UNITED STATES PATENT AND TRADEMARK OFFICE

APPLICATION NO.	FILING DATE	FIRST NAMED INVENTOR	ATTORNEY DOCKET NO.	CONFIRMATION NO.
10/600,879	06/20/2003	Joel David Limmer	169.12-0587	6664
164	7590	12/08/2005	EXAMINER	
KINNEY & LANGE, P.A. THE KINNEY & LANGE BUILDING 312 SOUTH THIRD STREET MINNEAPOLIS, MN 55415-1002			HEINZ, ALLEN J	
			ART UNIT	PAPER NUMBER
			2653

Office Action Summary

- 1) ☐ Notice of References Cited (PTO-892)
2) ☐ Notice of Draftsperson's Patent Drawing Review (PTO-948)
3) ☐ Information Disclosure Statement(s) (PTO-1449 or PTO/SB/08)
Paper No(s)/Mail Date _____.
4) ☐ Interview Summary (PTO-413)
Paper No(s)/Mail Date. _____.
5) ☐ Notice of Informal Patent Application (PTO-152)
6) ☒ Other: ADDENDUMS AB&BC.

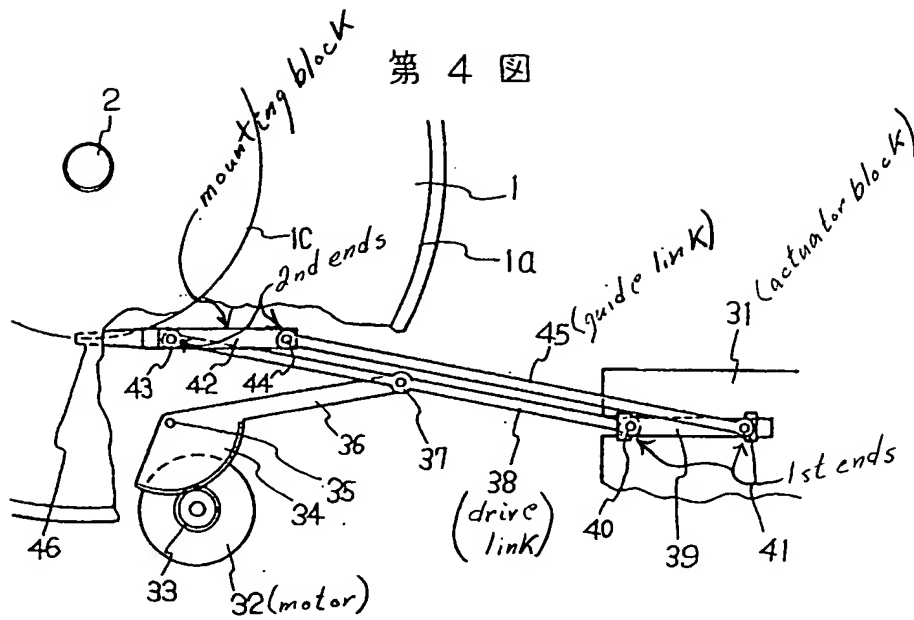
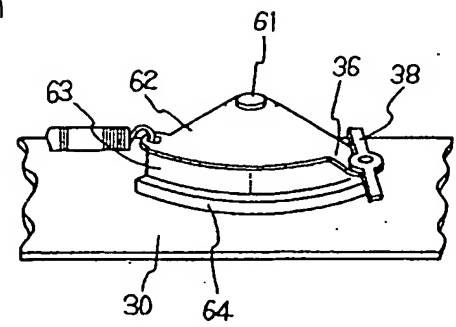
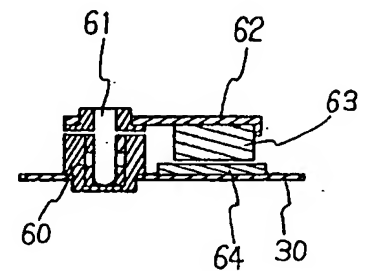
5. Claim 1-4,6,12,13 are rejected under 35 U.S.C. §102(b) as anticipated by the Japanese patent document (59-28216).

Note, to the extent claimed and understood, the structure as shown in Addendum BC (supplied with this office action) reads on and performs to the same degree as claimed.

The actuator motor 32 is operatively connected to drive link 38 via arm 36.

Re claim 4; because the claim fails to specify what is meant by 'flexible' and since all materials have some degree of elasticity or flexibility, the Japanese patent document's guide link is consistent with being a 'flexible' link.
